**Division of Reclamation,
Mining and Safety**

**RE: Rothe Sand and Gravel Pit, Permit No. M-1995-017
Amendment No. 01 application, AM01, Adequacy Review No. 1**

MINING SITE PLAT for LEE ROY ROTHE and MARLENE J. ROTHE

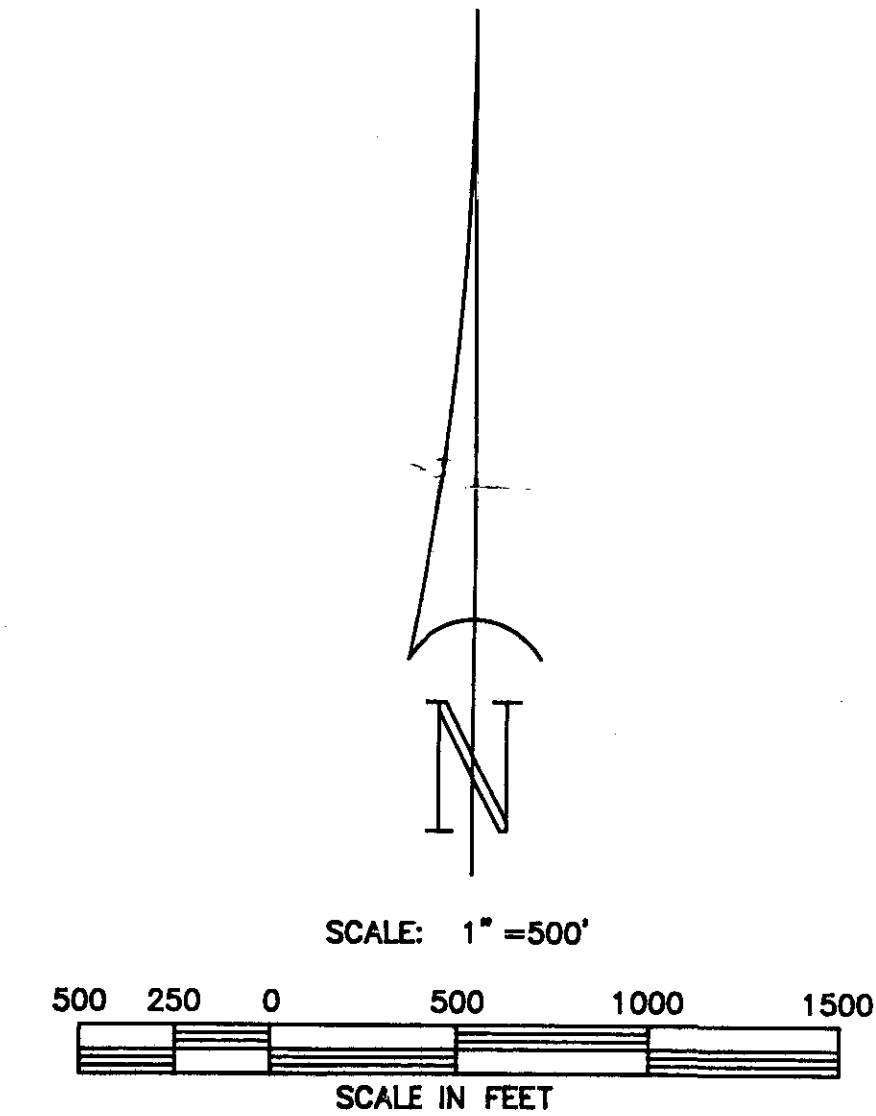
1. For the UTM coordinates provided for the main entrance to the mine site, please specify the Datum (NAD 1927, 1983, or WGS 84 etc.) used to find these coordinates and the applicable zone.
2. The affected land depicted on the Exhibit A map does not correspond to the currently approved affected land. Attached is a Mining Site Plat that depicts the affected area for the site. It appears the currently approved affected land has been disturbed by the mining operation and thus cannot be modified. Please revise the map to depict the currently approved affected land.
